Service Letter No. L 102 October 22, 2009

Z242L Aircraft, S/N 0679, 0681, 0682, 0683, 0684, 0685, 0742, 0745 and 0746.

Because above stated Z242L aircraft are operated in extreme cold conditions during winter periods, in order to prevent possible freezing oil vent lines, we permit below described modifications of aircraft oil system.

Fig. 1 - Oil breather line modifications for S/N 0679, 0681, 0682, 0683, 0684 and 0685

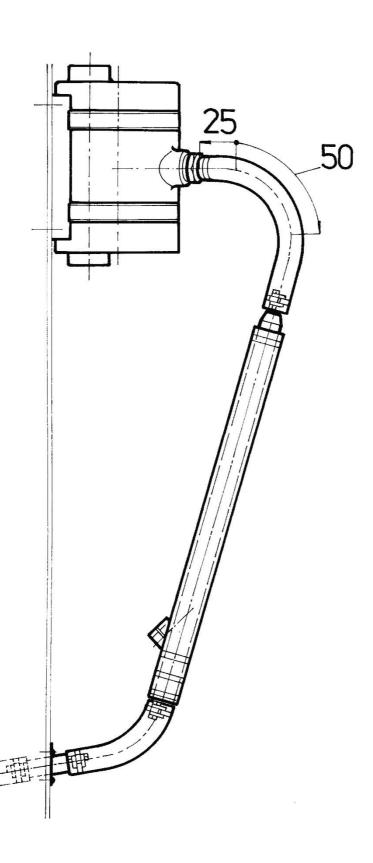
Replace original rubber hose between the air oil separator and the metal breather tube with hose material Stratoflex 193-10 (or equivalent). On this hose, in accordance with Fig. 1 below, make a 50 mm slice beginning 25 mm from the end of the fitting coming out of the air oil separator using a razor knife. The slice shall be orientated at the top of the hose in the direction of flow through the hose.

An insulation cover (fire sleeve Stratoflex 2650-13 or equivalent) shall be installed on the metal breather tube (including the short branch tube).

Fig. 2 - Oil breather line modifications for S/N 0679, 0681, 0682, 0683, 0684 and 0685

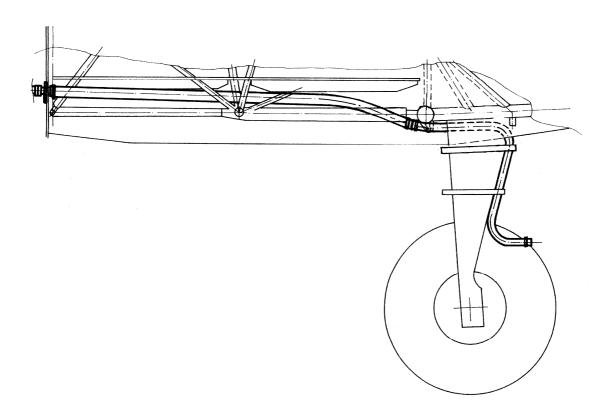
In addition, an insulation cover (fire sleeve Stratoflex 2650-13 or equivalent) on the metal tube which exits the fuselage and is routed down the trailing edge of the right gear leg shall be installed. See Fig. 2 below.

Fig. 3 - Oil breather line modifications for S/N 0742, 0745 and 0746

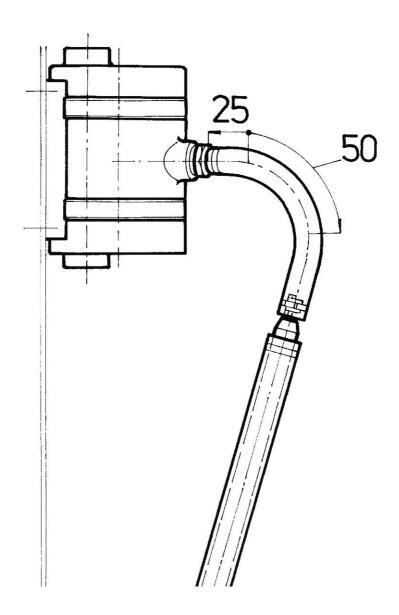
Replace original rubber hose between the air oil separator and the metal breather tube with hose material Stratoflex 193-10 (or equivalent). On this hose, in accordance with Fig. 3 below, make a 50 mm slice beginning 25 mm from the end of the fitting coming out of the air oil separator using a razor knife. The slice shall be orientated at the top of the hose in the direction of flow through the hose.

An insulation cover (fire sleeve Stratoflex 2650-13 or equivalent) shall be installed on the metal breather tube.

In addition to the slice in the flexible hose, drill a 5mm hole in the metal breather tube approximately 10mm above the upper clamp attaching the breather tube to the exhaust silencer and then use a 5mm diameter punch in order to internally offset the hole opening so that the flow of material inside the tube would be deflected towards the center of the tube instead of flowing out of the hole. The insulation cover (Stratoflex 2650-13 firesleeve) installed on the breather system metal tube coming from the air oil separator shall end above the 5mm hole so that it did not cover it.
